IHE Change Proposal

IHE Domain	Devices (DEV)
Change Proposal ID:	CP-DEV-001
Change Proposal Status:	Submitted
Date of last update:	2023-03-16
Person assigned:	Brian Witkowski

DEV TF Vol2 – PCD-03 appendix example corrections	
Submitter's Name(s) and e-mail address(es):	Brian Witkowski, brian_witkowski@baxter.com
Submission Date:	2024-05-03
Integration Profile(s) affected:	Point-of-Care Infusion Verification (PIV)
Actor(s) affected:	Infusion Order Consumer (IOC)
IHE Technical Framework or Supplement modified:	Appendix E in DEV TF, revision 9.0, dated Dec 12, 2019
Volume(s) and Section(s) affected:	Vol 2, changes and additions to E.2

DEV TF Vol2 - PCD-03 appendix example corrections

Section E.2 **E.2.2 Interaction Diagram**, update diagram to include IOC sending Application Acknowledgement to IOP, page 179, line 4565; **E.2.3 Messages**, update HL7 to reflect reality and correct errors:

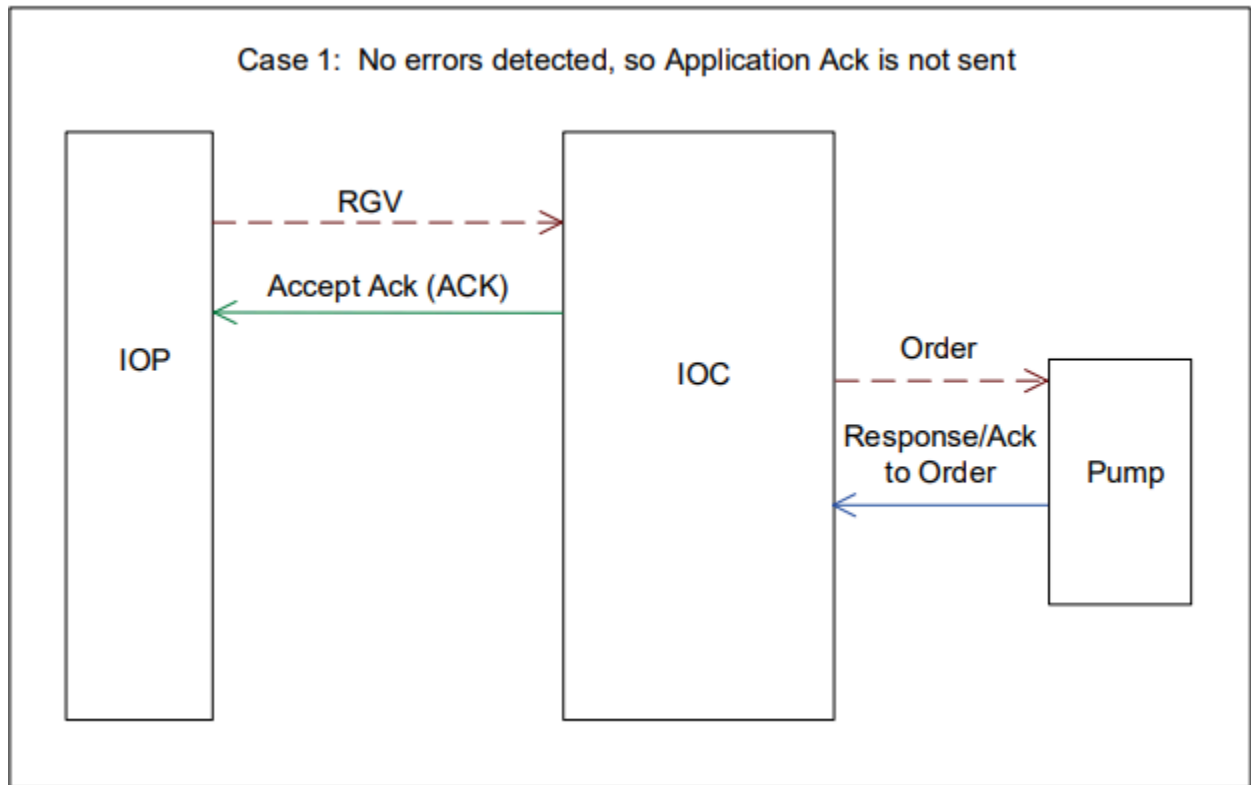
Change

To include a yellow-colored arrow (matching the other examples in this section) pointing one-way from the IOC to the IOP with a label of “Application Ack (RRG)” above it. This arrow and label should be placed below the green arrow with comfortable spacing and the label should have centered text with the other labels above it. Below the yellow arrow, the text “MSA-1 indicates success or failure” should be added. The label at the top of the diagram should also be changed to not state “Application Ack is not sent”, since that is false.

For Case 2 and Case 3 diagrams below this one, add the text “MSA-1 indicates failure” below the existing yellow lines for Application Ack (RRG).

In the block diagrams for Case 1, Case 2, and Case 3, add an arrow for the Accept ACK from the IOP to the IOC
